INDESIT company

Model type:
WITP82EU

Commercial code:
F034265

n1040345: Replacement of drum lock button TL EVOII.

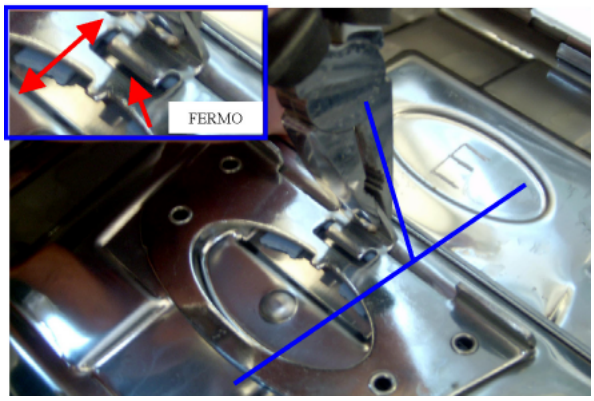
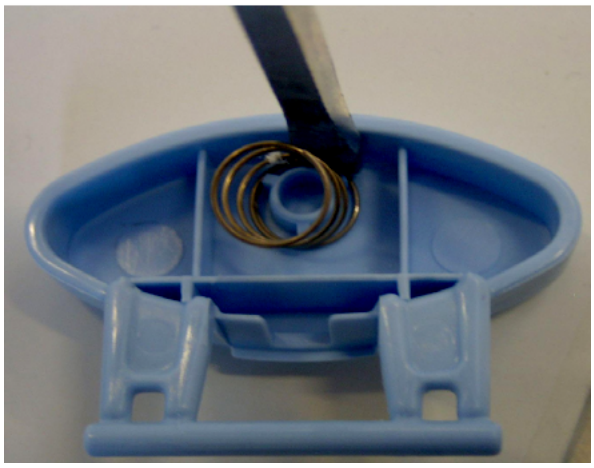
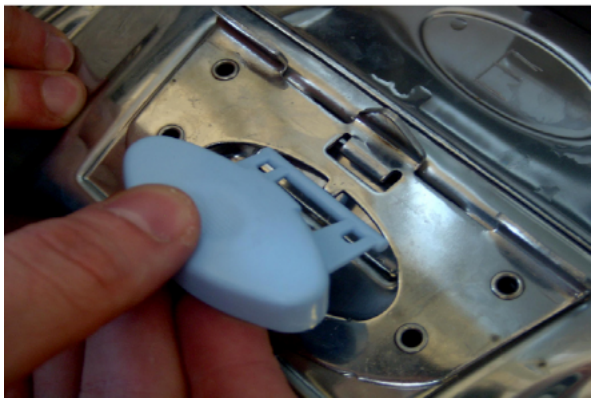
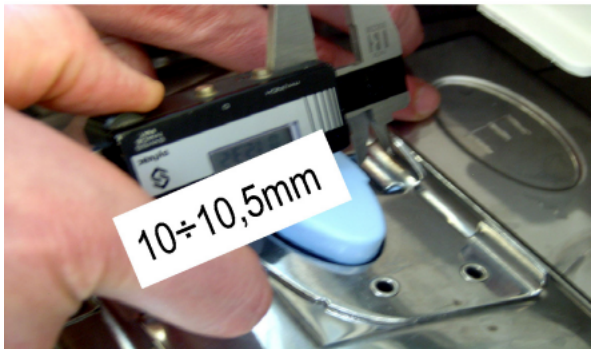
Tools and material needed: pliers, screwdriver, gauge, spring P/N Sat 114989, button P/N Sat 114990.

1) turn the central tip of the catch in the direction shown (FIG.1);

2) bring the tip to a vertical position and ensure that the broken button is disengaged from the catch restraint and can be removed (FIG.2);

3) remove the remaining part of the button with the aid of a screwdriver, taking care not to scratch the doors (FIG.3);

4) pre-assemble spring to button (FIG.4);

5) insert button between catch and door (FIG.5);

6) bring the button into position and arrange the spring in its location in the door (FIG.6);

7) turn the central tip of the catch in the direction shown to return it to its starting position (FIG.7);

8) check the distance between button and catch (FIG.8);

9) check correct operation of the button when opening and closing the doors (slight inclination errors of the catch can result in

faulty closing of the doors) (FIG.9).

n1040382: Drain pump with bayonet-style filter - top Loading Brembate

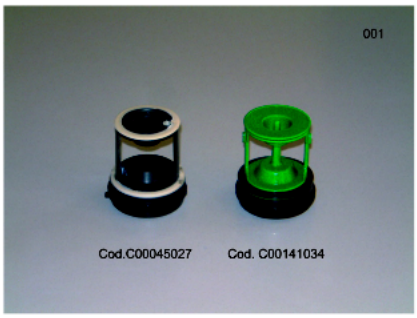
From serial no. 51021.0001 a new drain pump with bayonet-style filter has been installed on all top loading washing machines manufactured in Brembate.

New parts:
C00141862 - Drain pump
C00141034 - Pump filter kit

Premodification parts:
C00111409 - Drain pump
C00045027 - Pump filter kit

The new parts can be used instead of premodification ones.

N1040404FIG1

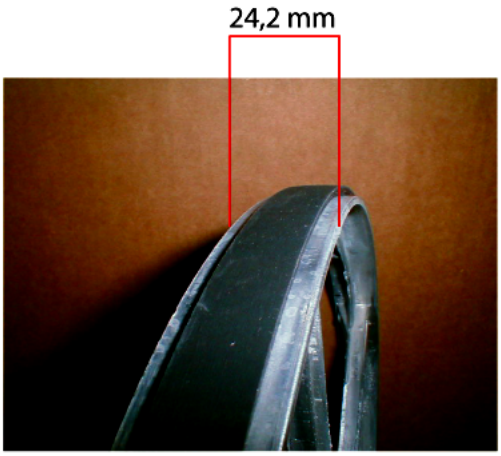
n1040404: New pulley installed on top loading washing machines up to 1000RPM (NO tub lock)

From serial no. 51202.0001 the pulley track has been widened from 21.2mm to 24.2mm (see picture N1040404FIG1).

new pulley
C00142832 - D280 24.2 mm track

Premodification pulley
C00083912 - D280 21.2 mm track

The new pulley can also be used on premodification versions of the models referred to in this release.
